SERVICE DIRECTIVE BULLETIN NO. T-033

Revision 1

1. SUBJECT: Inspection of Tailcone Skins, Flanges, and Longerons
2. MODEL: TH-28, 480, and 480B
3. EFFECTIVITY: All Serial Numbers
4. BACKGROUND:

Figure 1. Tailcone Structure – Top and Bottom Skins and #3 and #4 Bulkheads

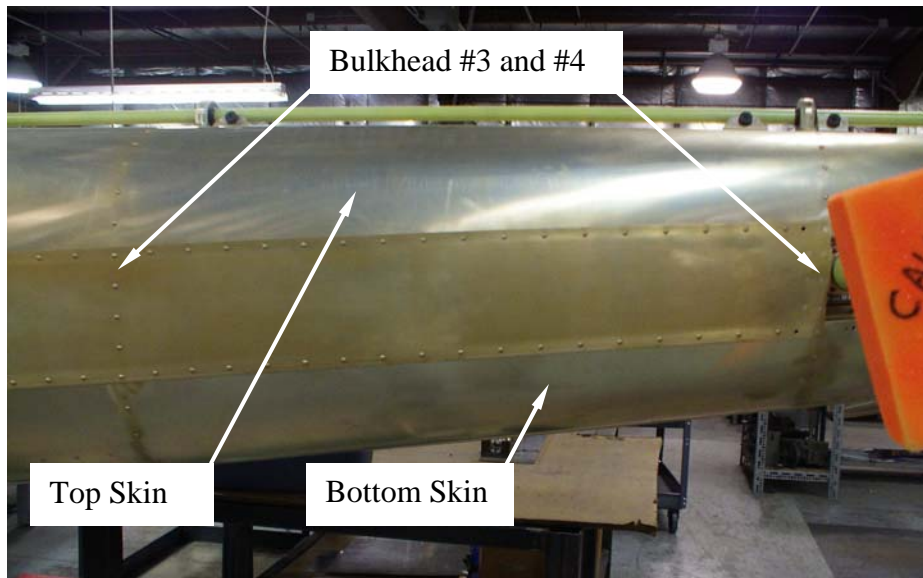
- A. Visually inspect the top and bottom skins along the entire length of the tailcone for cracks, bends or dents. Reference Figure 1.
- B. Visually inspect the V-rib along the bottom skin for any cracks, bends, or dents. Reference Figure 2.
- C. Dents that are less than 3" (76.2 mm) long and less than 3" (76.2 mm) wide and 1/8" (3.175 mm) deep or less are allowed in the areas shown in Figure 4. No dents are allowed in areas of tighter radii, rivet lines, or in the V-rib.
- D. If cracks, bends, or dents that exceed the size allowance are detected, or are outside the allowable areas, they must be repaired in accordance with paragraph 5.3.

Figure 3. Tailcone Structure – Interior Skin Flanges and Longeron

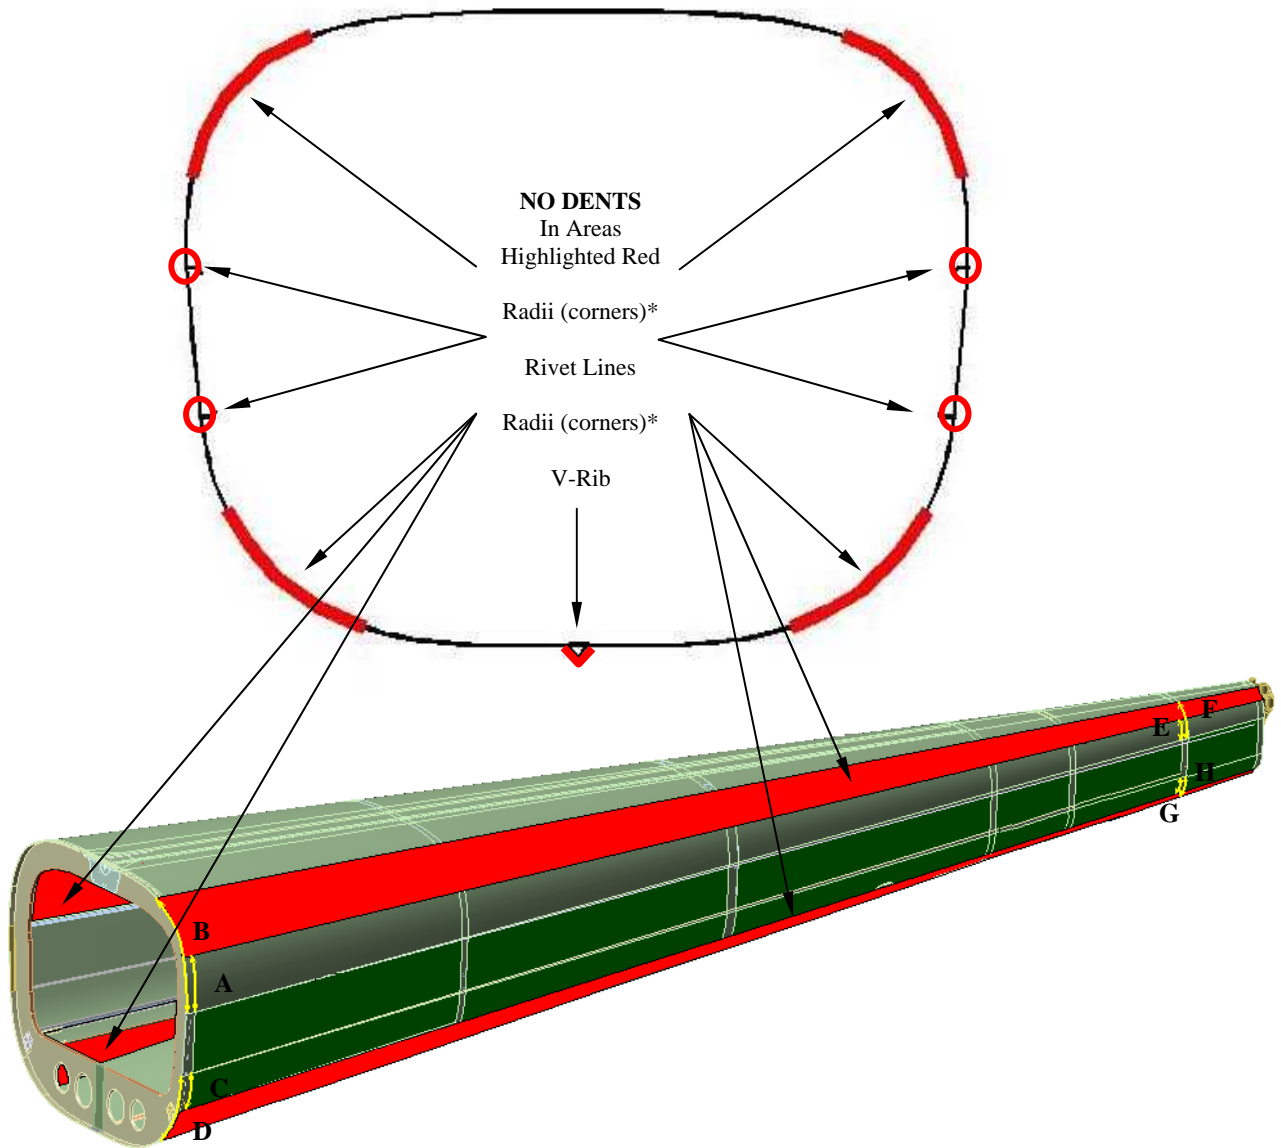
- D. Visually inspect the interior top and bottom skin flanges on both the left and right side of the tailcone for any cracks, bends, or dents. Reference Figure 3.
- E. Visually inspect the interior longerons on both the left and right side of the tailcone for cracks, bends or dents. Reference Figure 3.
- F. If cracks, bends or dents are detected, proceed to paragraph 5.3

Figure 4. Red Highlighted Tailcone Regions Indicate Where Dents are NOT Allowed. Dents within the allowable size are allowed in remaining tailcone regions.

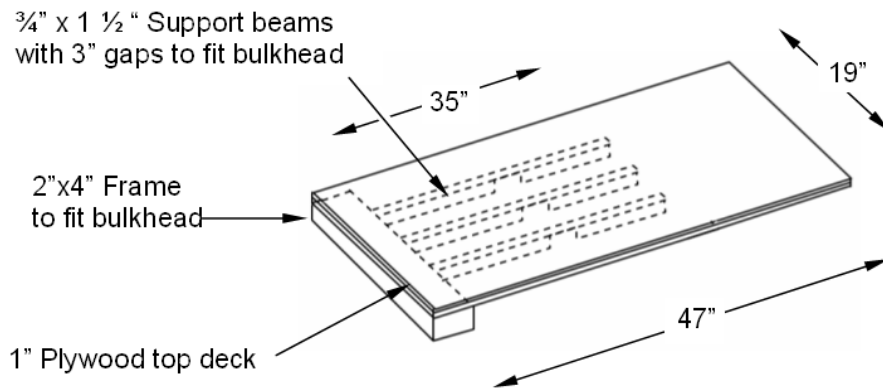
Locating Critical Radii Circumferentially in the Tailcone					
Forward End of Tailcone			Station 327.09 Approximately 10 inches (254 mm) Forward of Aft End of Tailcone		
A	Upper tailcone Rivet line to radius	4 inches (101.6 mm)	E	Upper tailcone Rivet line to radius	2 inches (50.8 mm)
B	Upper tailcone Rivet line to opposite end of radius	11 inches (279.4 mm)	F	Upper tailcone Rivet line to opposite end of radius	4 inches (101.6 mm)
C	Lower tailcone Rivet line to radius	4 inches (101.6 mm)	G	Lower tailcone Rivet line to radius	1 inch (25.4 mm)
D	Lower tailcone Rivet line to opposite end of radius	11 inches (279.4 mm)	H	Lower tailcone Rivet line to opposite end of radius	4 inches (101.6 mm)

Figure 5. Boards to Aid Inspection
(See also Figure 6)
Side enclosures are not installed for picture only.

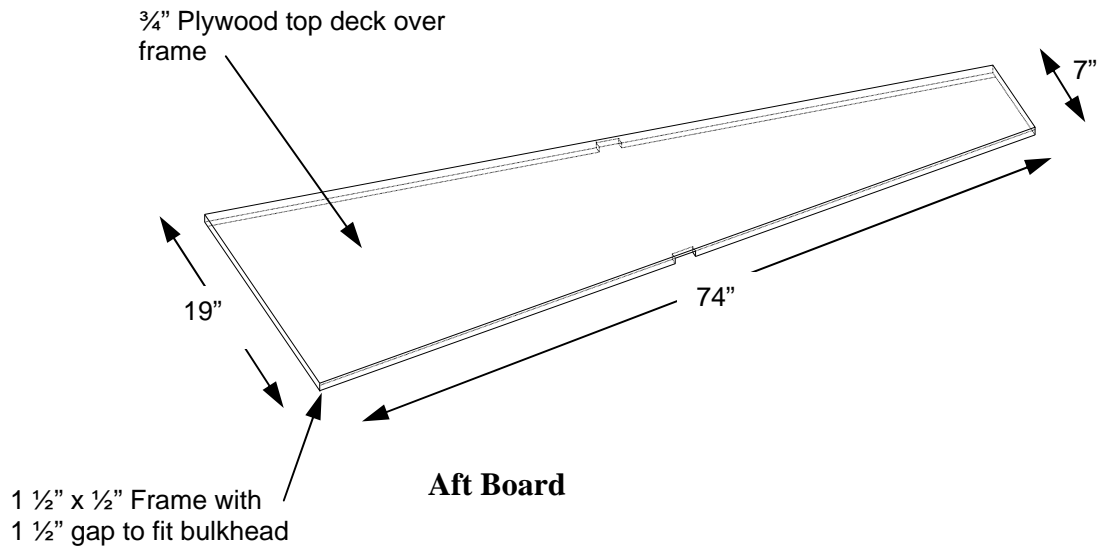
- A. Perform external check listed under 5.1 above.
- B. Remove the side cowls and aft baggage box floor and bulkhead on both the left and right side of the tailcone.
- C. Place support boards on the bulkheads inside the tailcone to aid inspection. The boards may be constructed of plywood and framed on the bottom for reinforcement. Reference Figure 5 and Figure 6 for sample board construction.
